# City of Hidden Hills

## ADDENDUM NO. 1 City of Hidden Hills Fiber to Homes Project

SUBJECT TRENCH ALIGNMENT  
 TYPE OF CONST DUCT PLACEMENT  
 DWG 11 OF 19

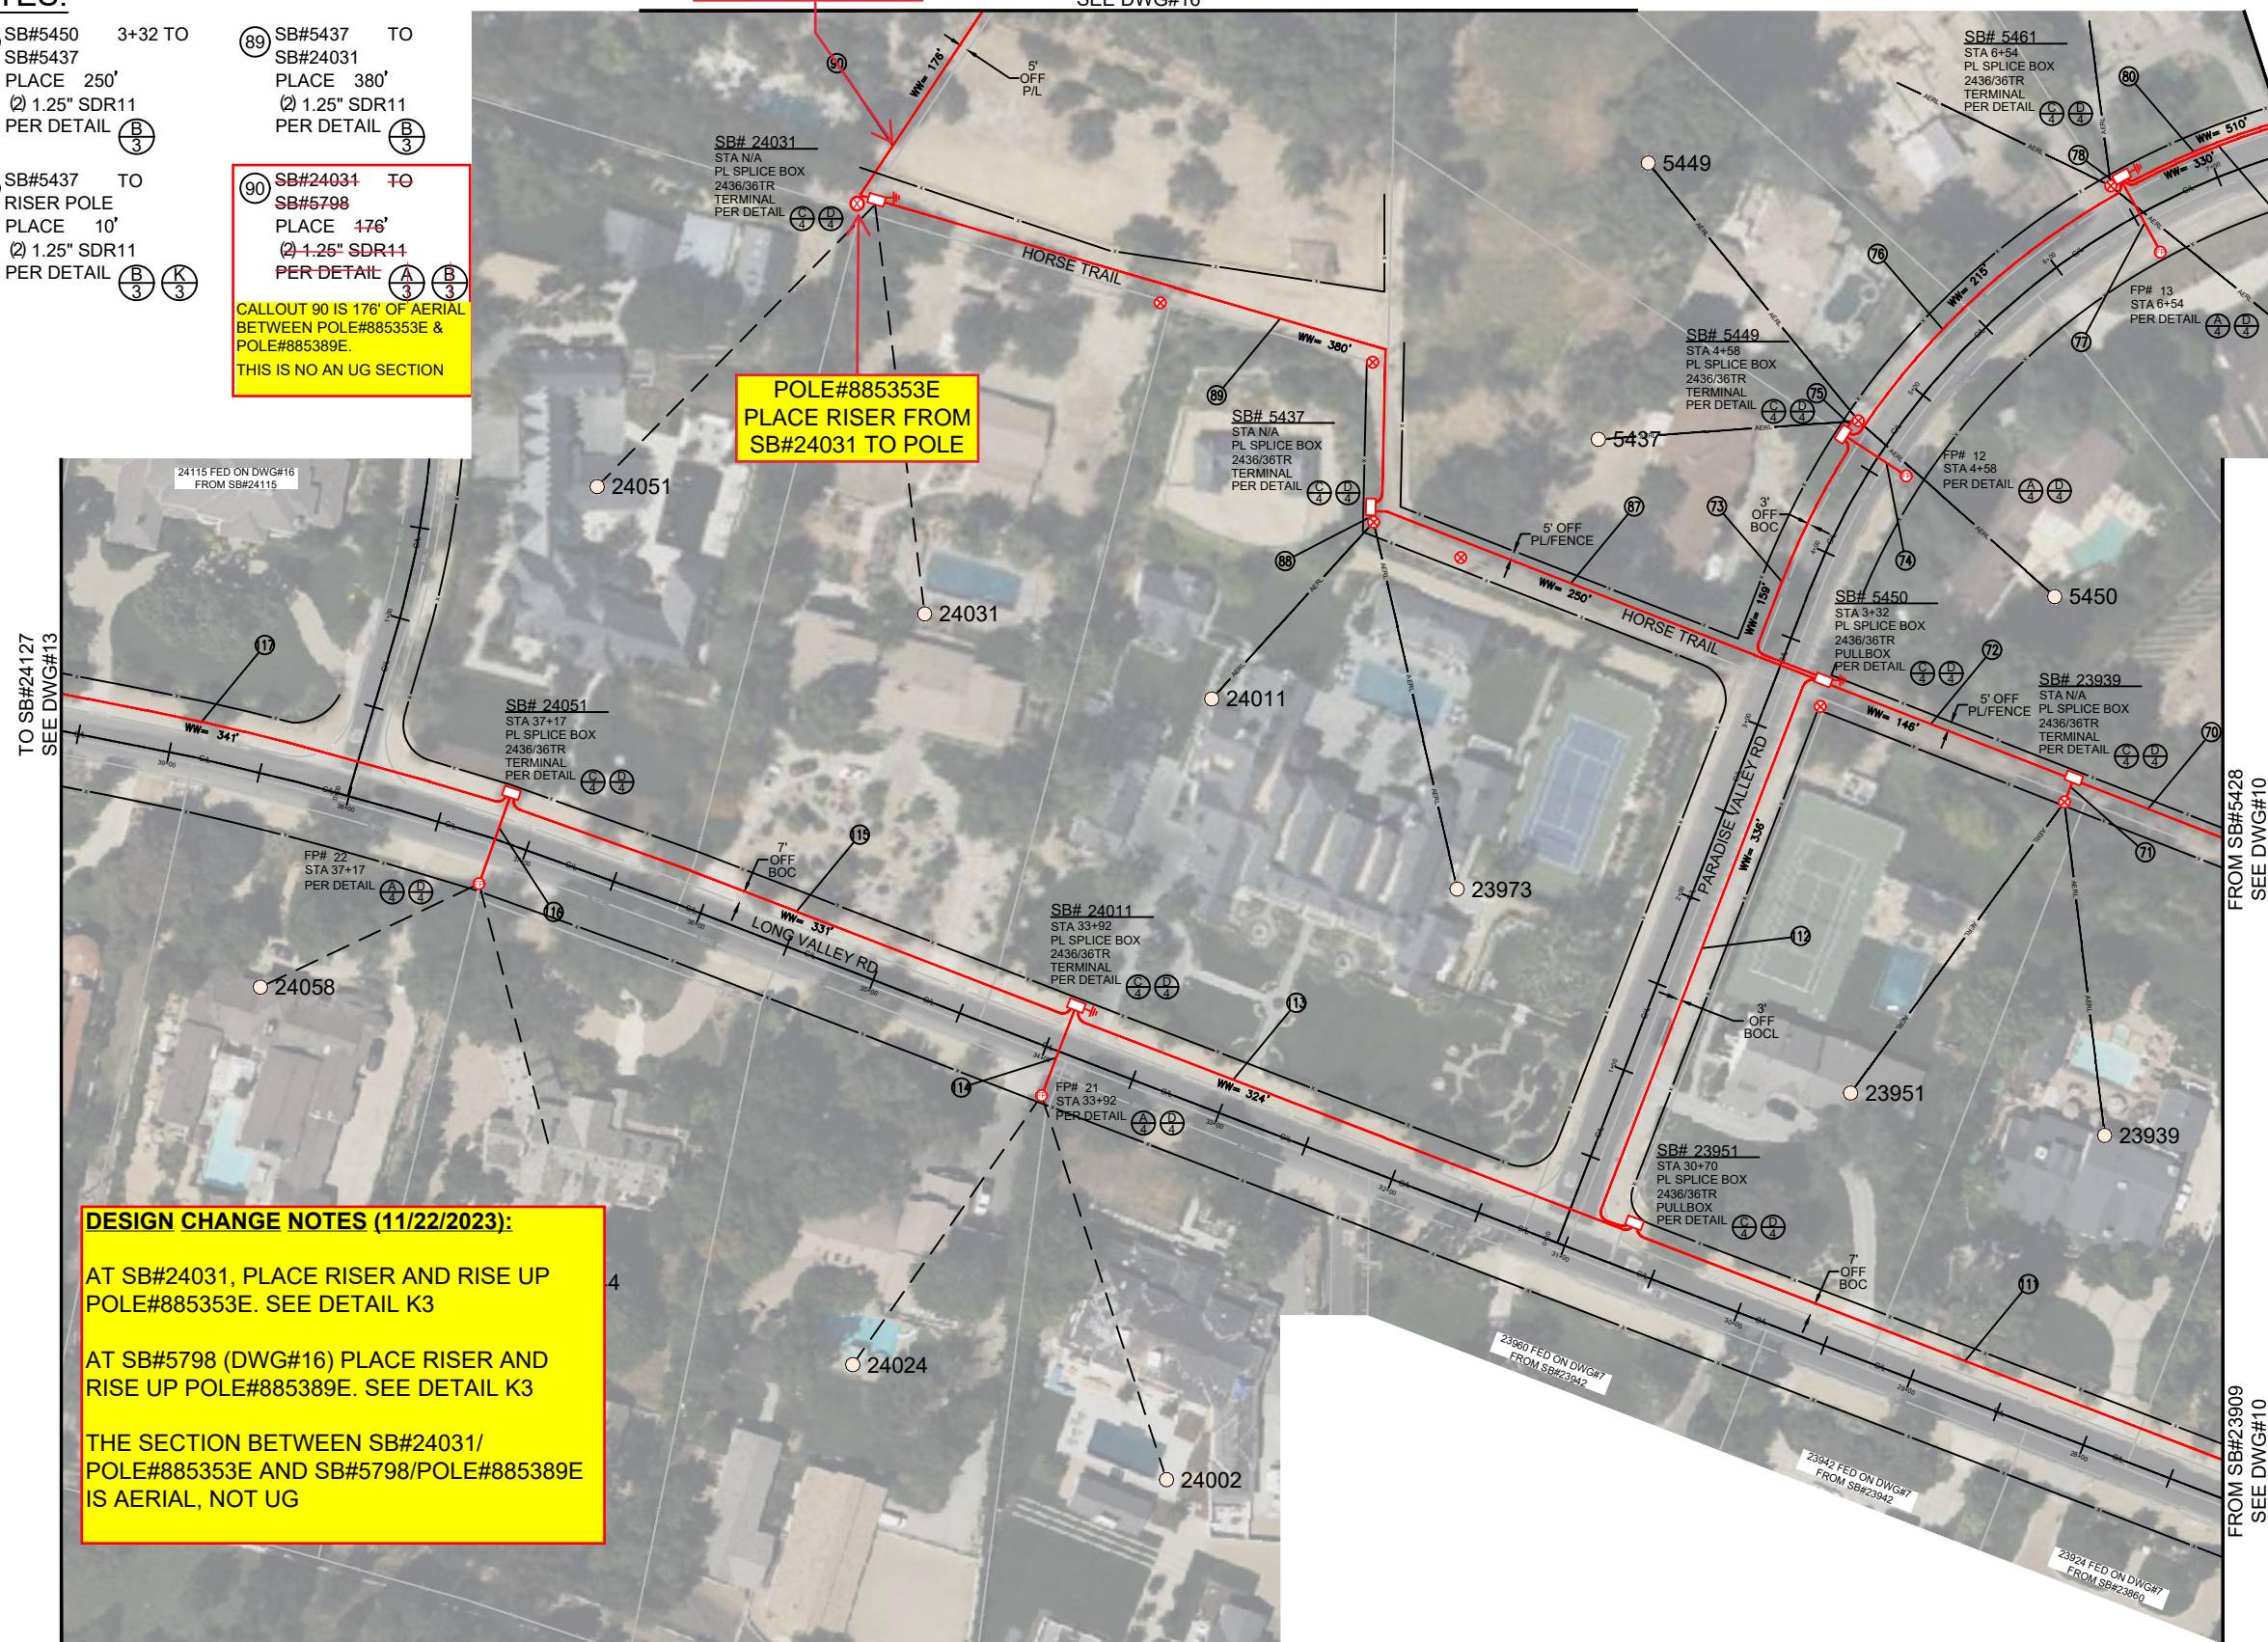
Line 90 at the end of Penland Road shall be located aurally on existing poles, per attached revised DWG's 11 and 16.

**CALLOUT 90 IS 176' OF AERIAL BETWEEN POLE#885353E & POLE#885389E. THIS IS NO AN UG SECTION**

**DESIGN CHANGE NOTES (11/22/2023):**

AT SB#24031, PLACE RISER AND RISE UP POLE#885353E. SEE DETAIL K3

THE SECTION BETWEEN SB#24031/ POLE#885353E AND SB#5798/POLE#885389E IS AERIAL, NOT UG

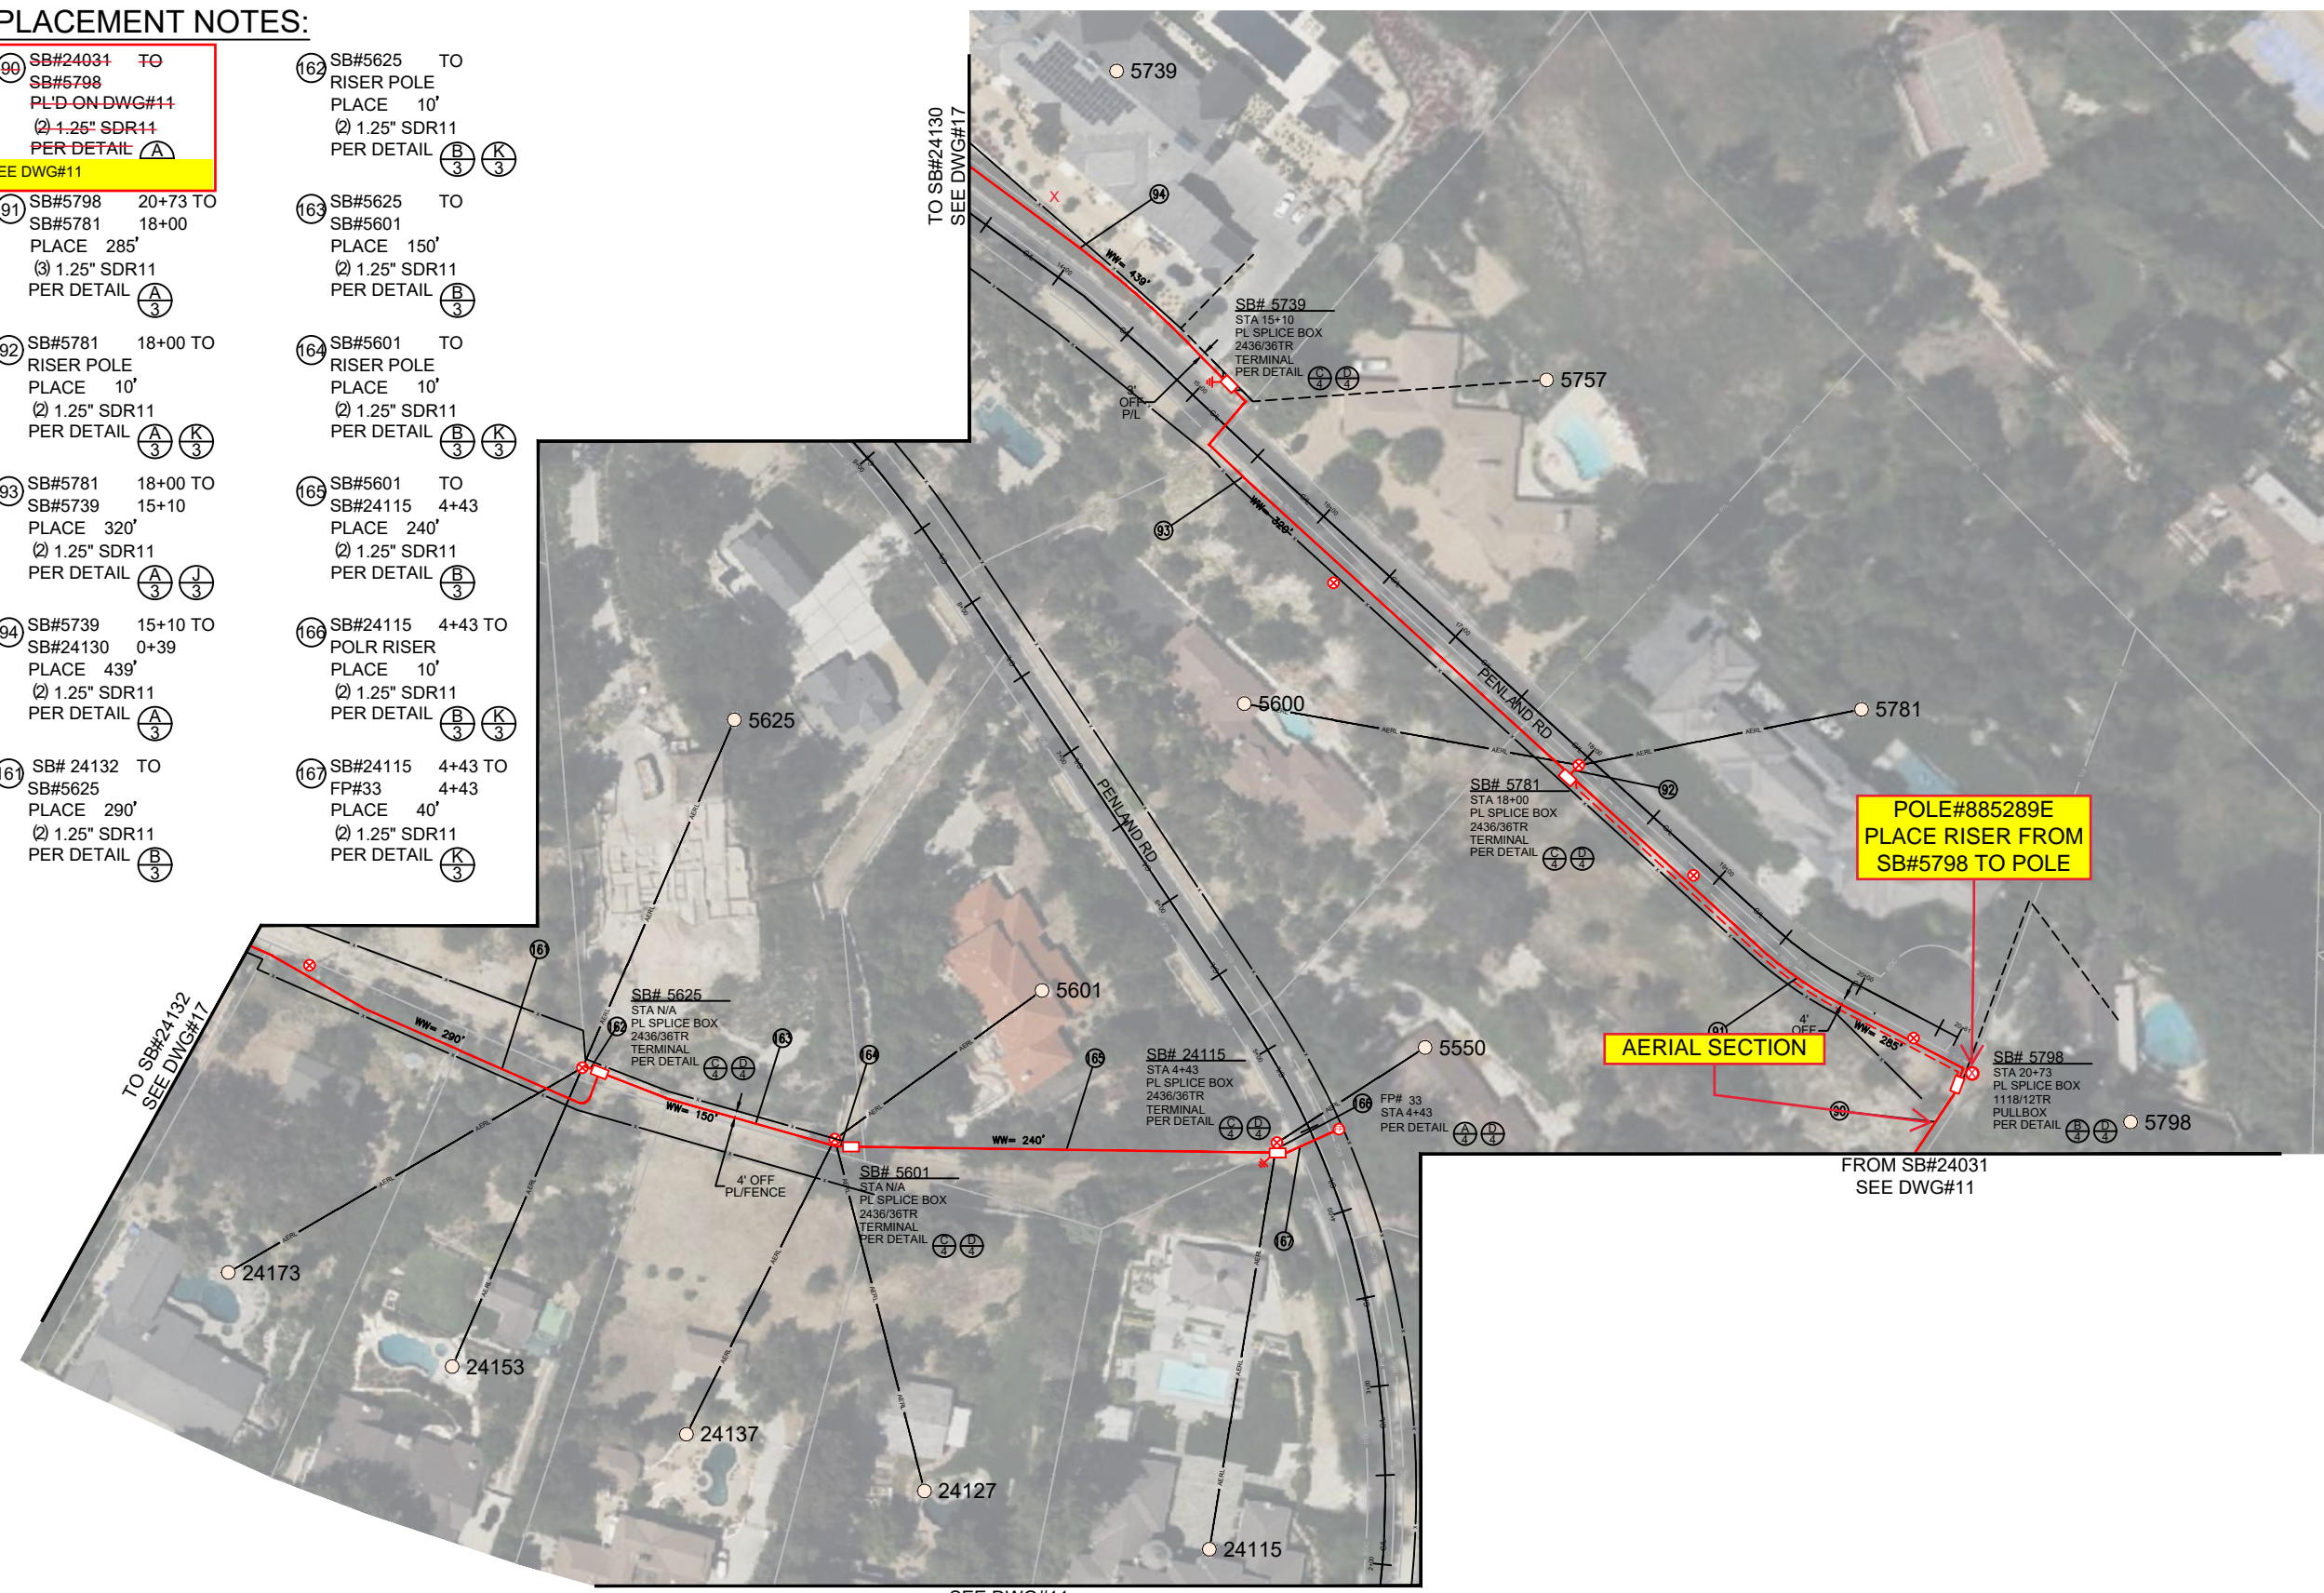
Line 94 on Penland Road is to be relocated to the bottom of slope, behind the BOC.

AT SB#5798 (DWG#16) PLACE RISER AND RISE UP POLE#885389E. SEE DETAIL K3
